**REVIEW AND ASSESSMENT OF  
THE LAPROMED FACILITY**

**GUATEMALA CITY**

**TECHNOLOGIES FOR PRIMARY HEALTH CARE (PRITECH) PROJECT**

**ATTACHMENT 1**

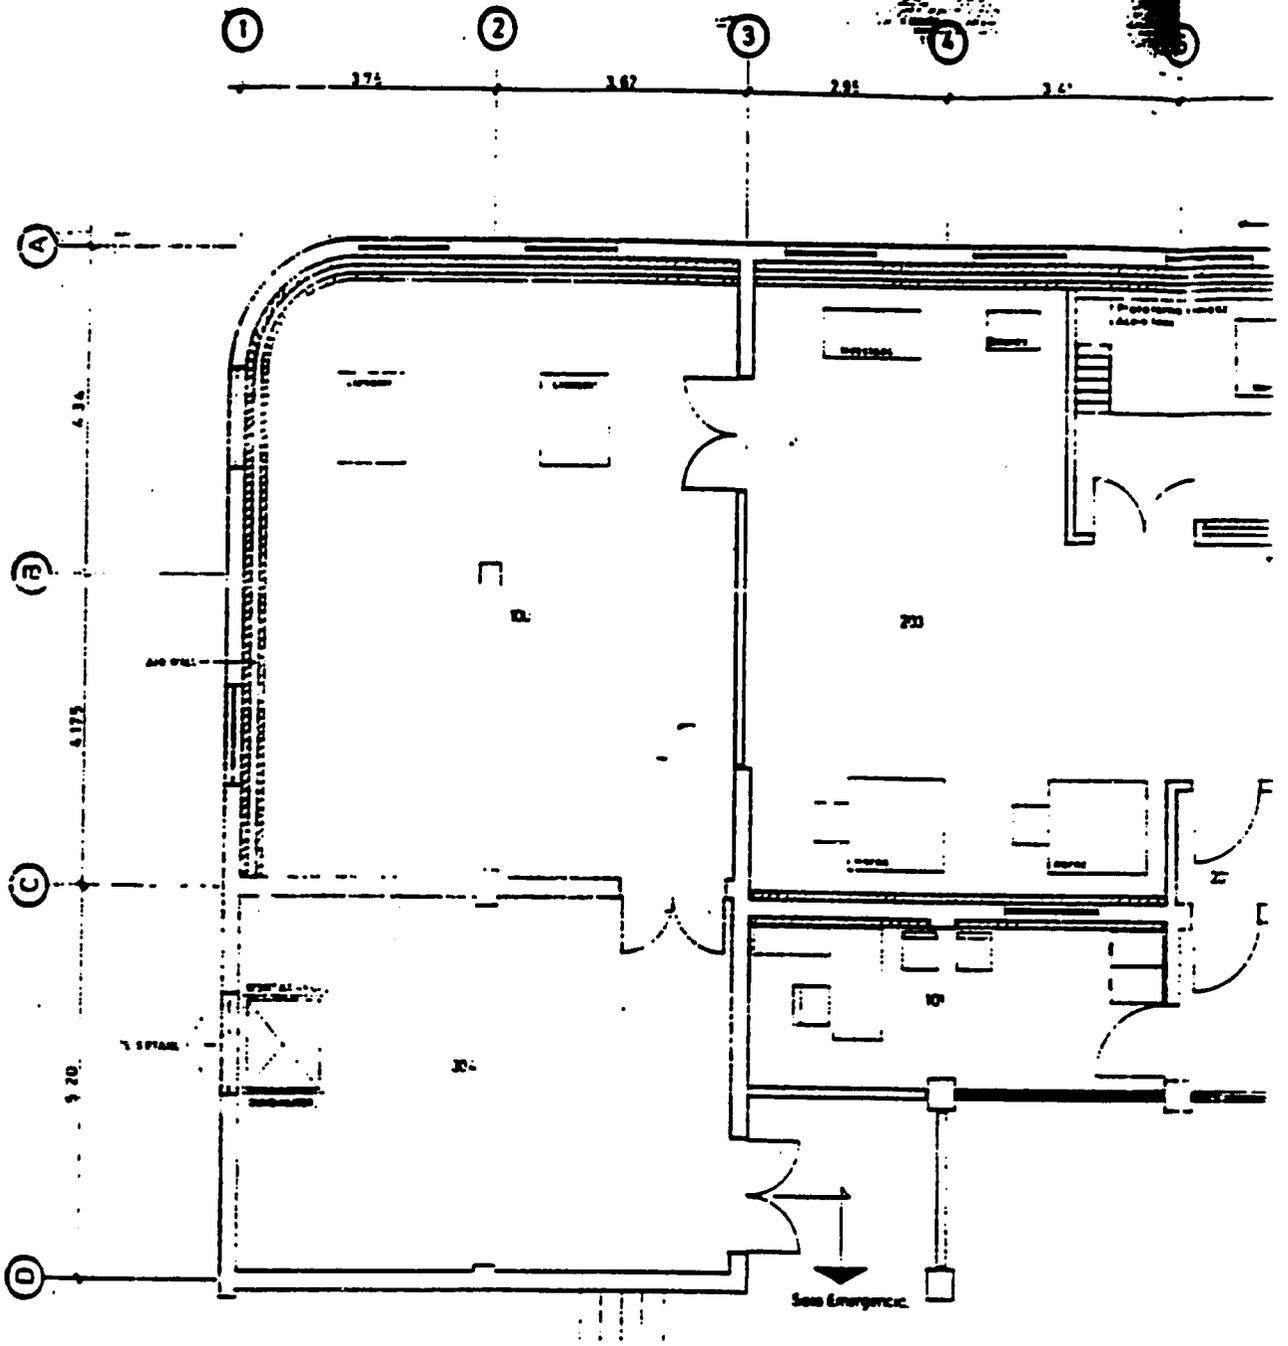
The team proposes maintaining the transformer currently located on a pole outside the building on 7<sup>a</sup> Avenida. From that transformer, cables will be brought into a proposed switchboard to be located in Room 304. This proposed switchboard should have one switch for every piece of equipment using three-phase power and one separate switch for the air conditioning unit. Units demanding lower power can be combined per local regulations.

Equipment that can generate dust, e.g., mill and sifter, will be located in Room 200. This room will be connected to a separate air system. This system will also serve three additional rooms—Room 203 (drying and mixing area), Room 202 (corridor for compounding), and Room 201 (air lock to compounding area).

A main air system will operate independently for Room 100 (dosing/packing area) and Room 101 (production office).

A separate air system will provide air for the cleaning and service areas which includes Room 300 (equipment washing), Room 301 (air lock from the warehouse), Room 307 (employees' changing rooms), Room 306 (buffer zone), and Rooms 302 and 303 (rest rooms).

- The existing floor in the MFG areas is of terrazzo and needs only to be regrinded and polished.
- The floors for the raw material storage area (Room 309) and quarantine area for finished products (Room 304) are of poor ceramic tiles and must be removed and replaced with a smooth concrete floor.

Relocation of the raw material storage area to Room 309 will also permit the building of an unloading dock at the street level, thereby alleviating the currently cumbersome process of moving raw material upstairs through the main building entrance.

- A pallet lift be built in the finished product quarantine area (Room 304) to facilitate product removal.
- Doors be enlarged to permit easy flow of pallets, the pallet hand-lift, drums, and carts carrying finished goods.
- ORS equipment and ancillary must be rinsed with purified water to avoid presence of heavy metals, particulate, and microorganisms. It is possible to move Lapromed's existing water still to the floor above and provide piping to feed ORS and pharmaceuticals by a gravity, no-return system.
